ADDENDUM NO. 1 TO BID FORMS

**CORONA-NORCO UNIFIED SCHOOL DISTRICT
PURCHASING DEPARTMENT
Bid No. 2023/24-204**

CORONA FUNDAMENTAL INTERMEDIATE SCHOOL MPR MODERNIZATION

SHEET NO.:
G-101

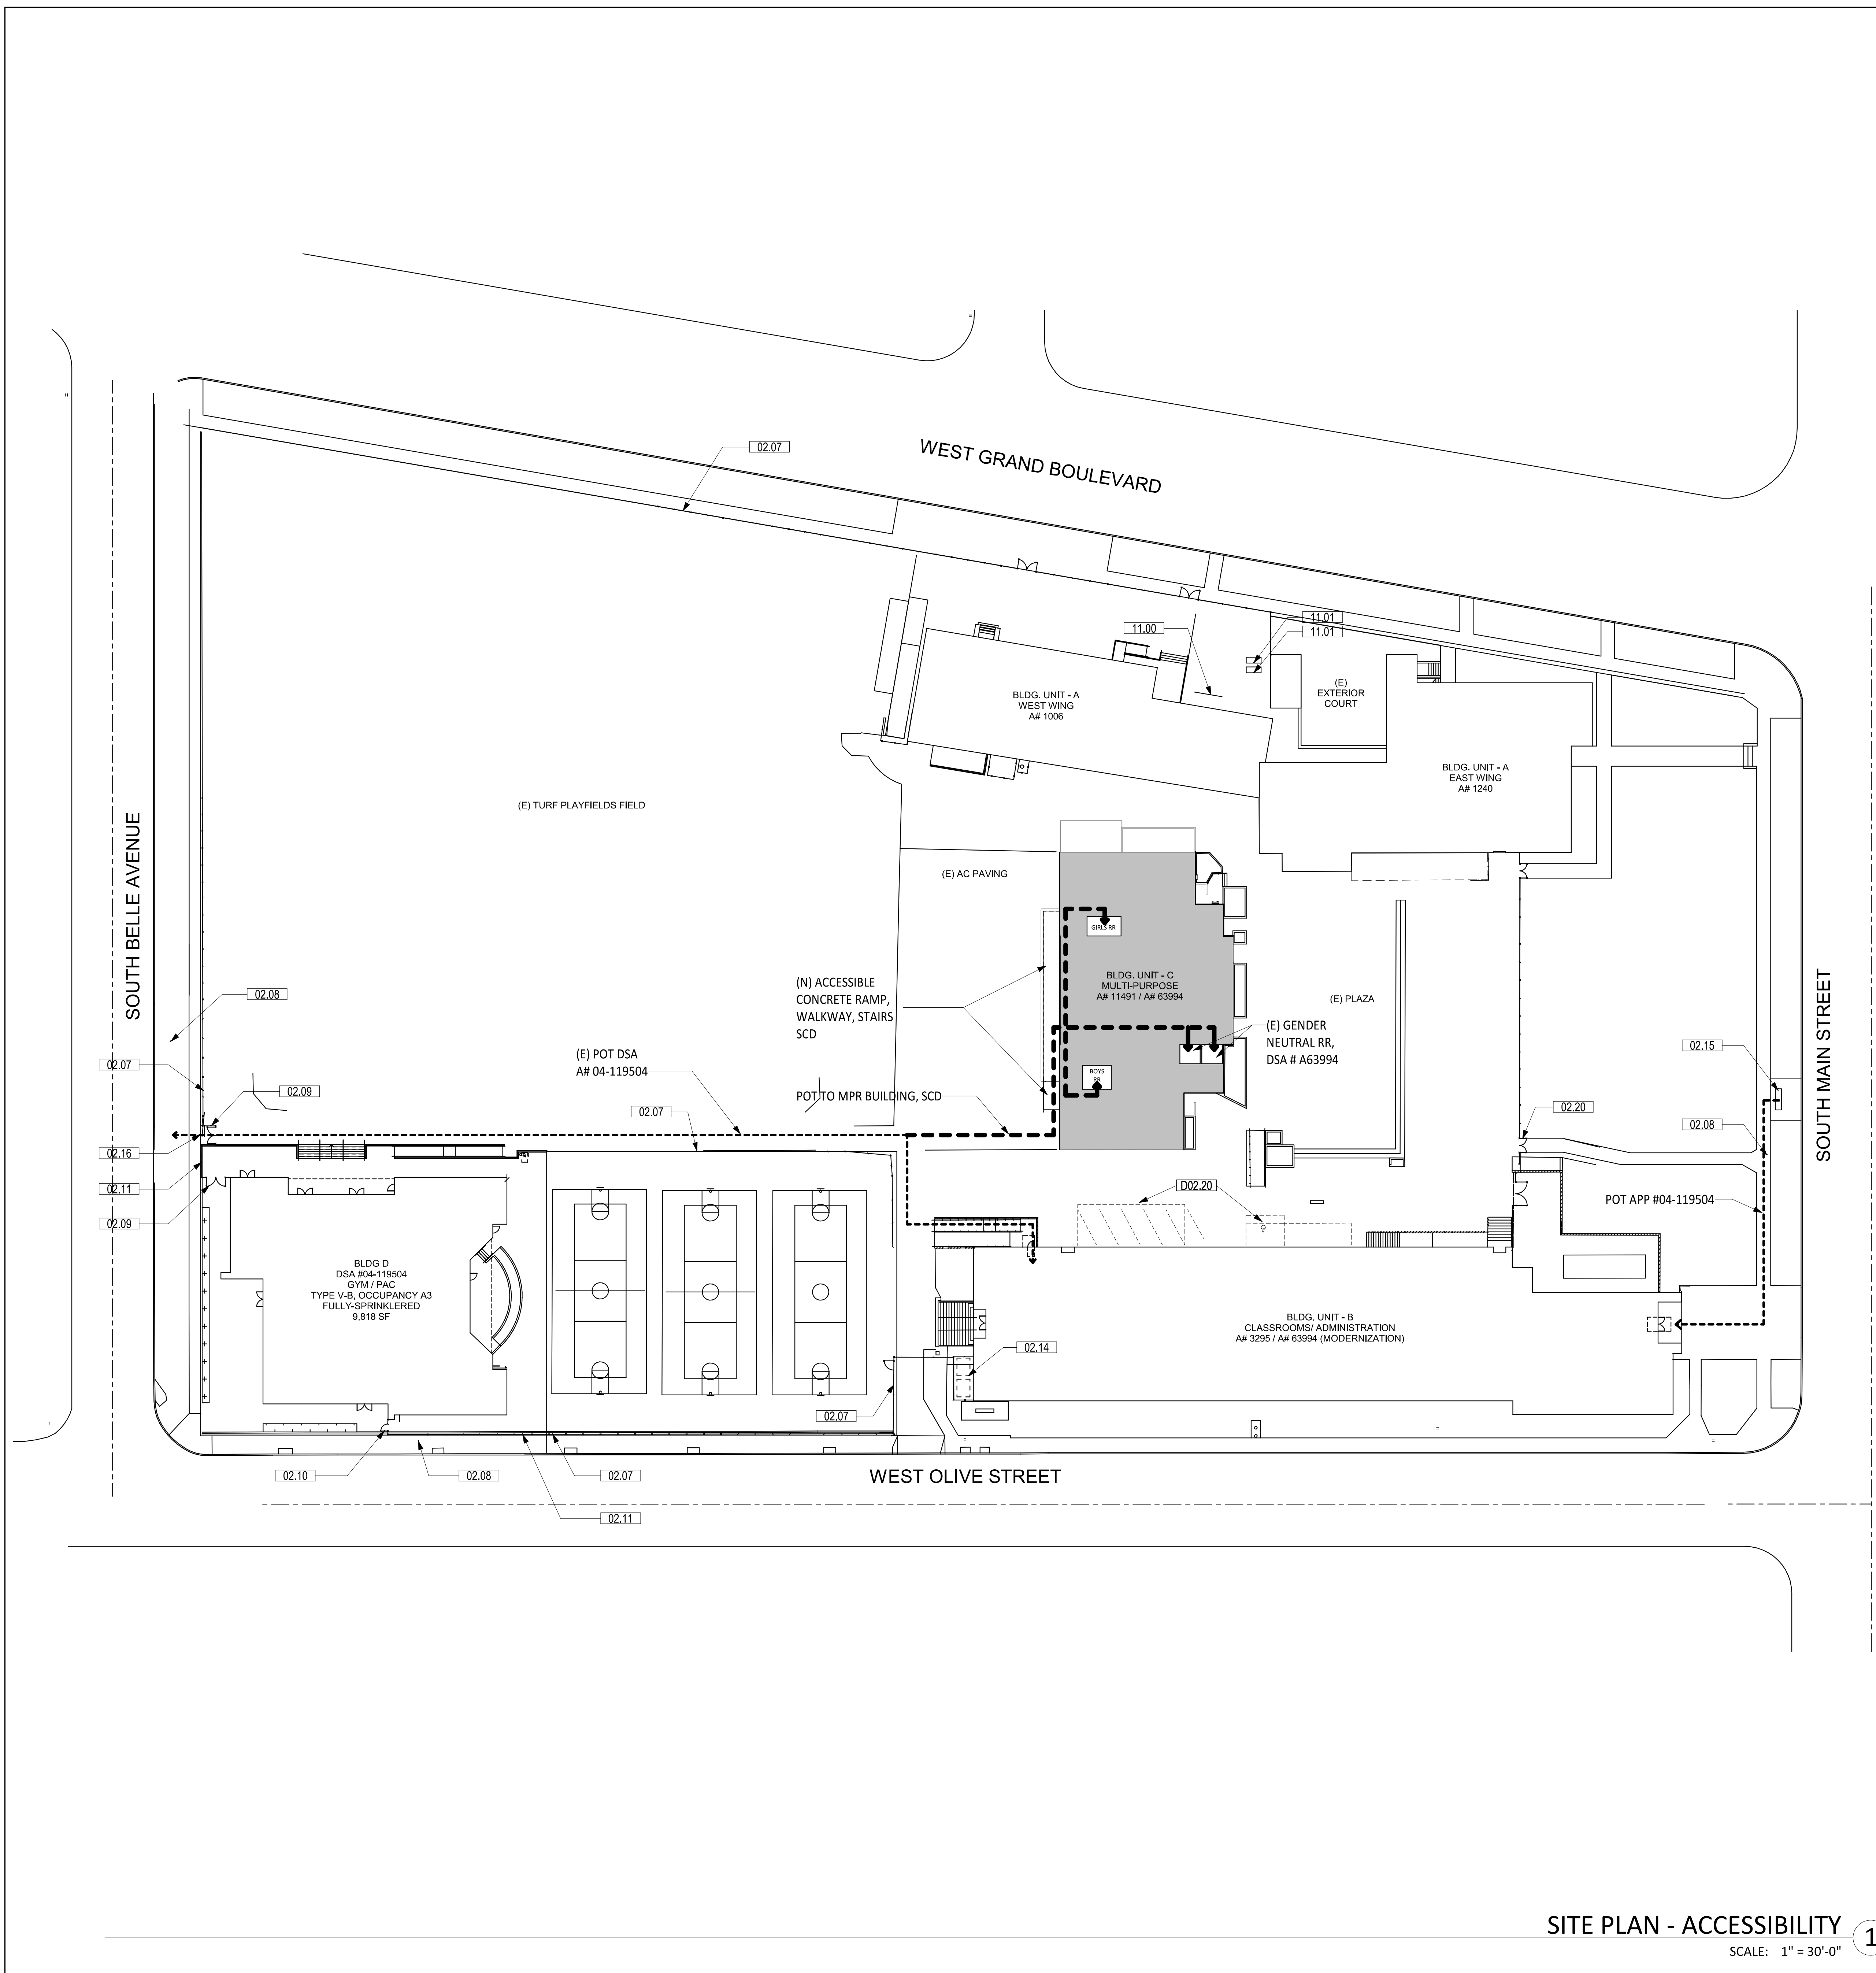
Item No. 1.01
Sheet G-101 - SITE PLAN - OVERALL - ACCESSIBILITY

- Sheet notes regarding sheet G-102 removed.

SHEET NO.:
A-101

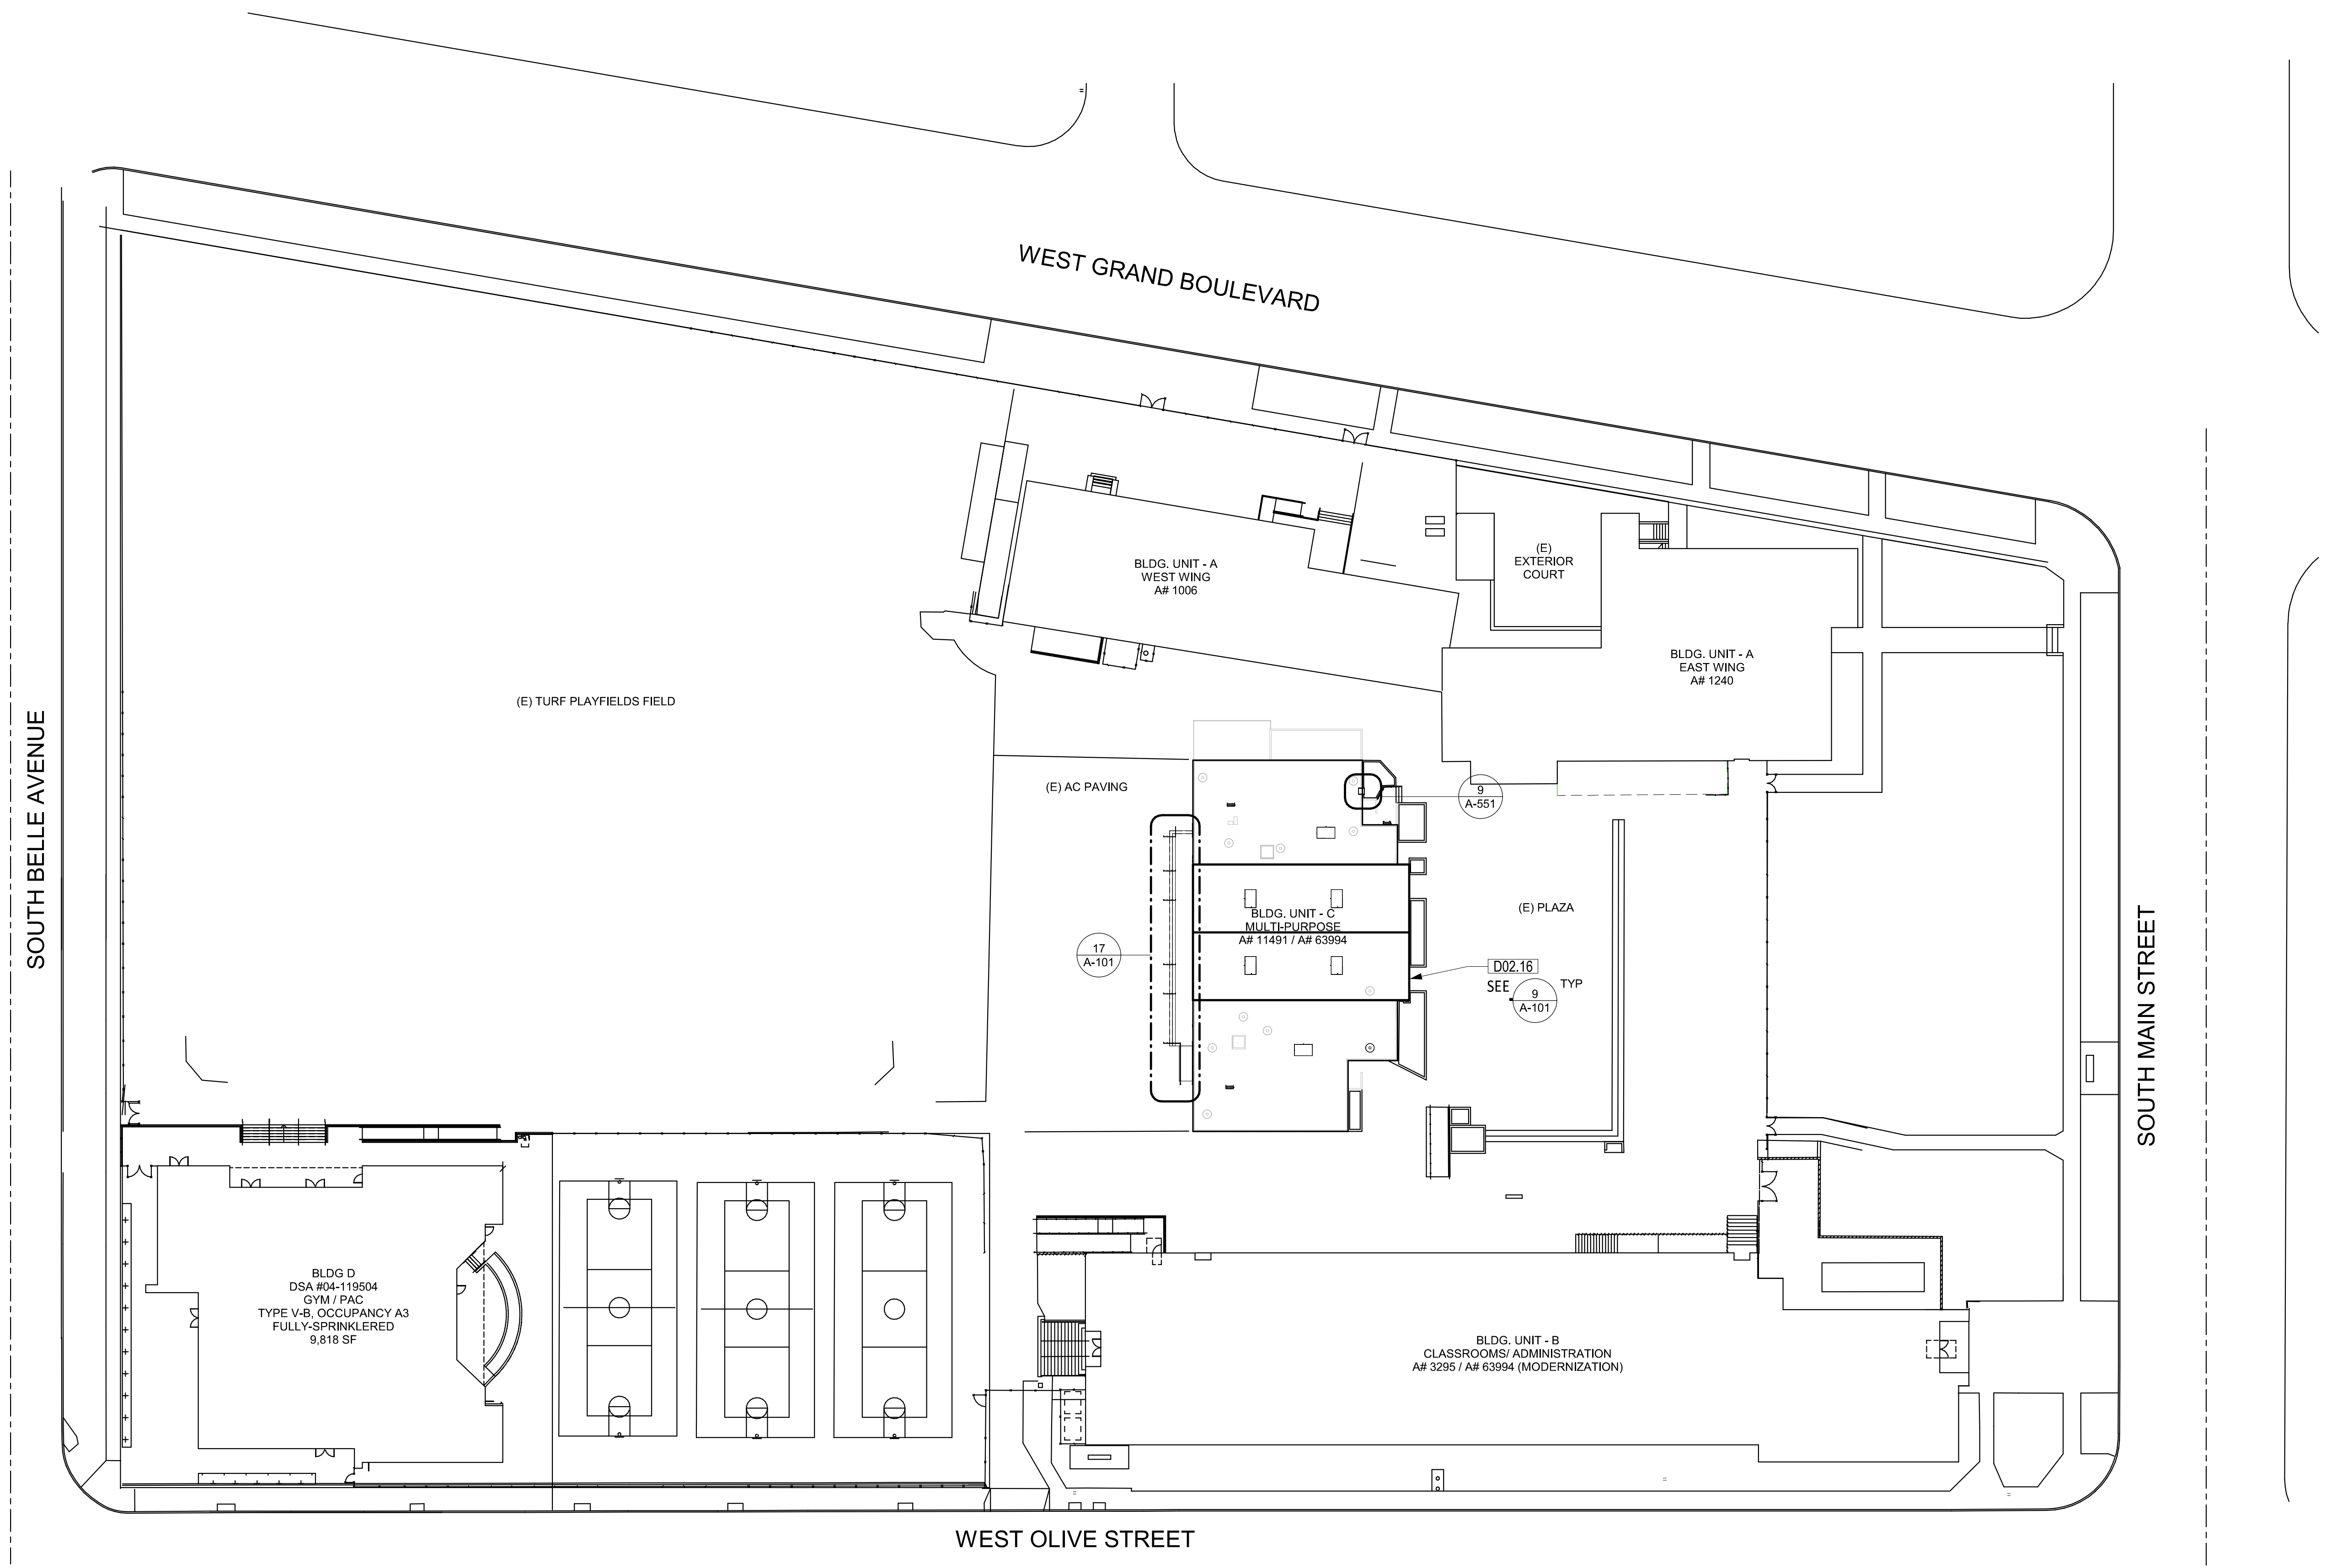
Item No. 1.02
Sheet A-101 - SITE PLAN - OVERALL & DETAILS

- West concrete landing layout revised
- Remove handrail, added continues concrete step
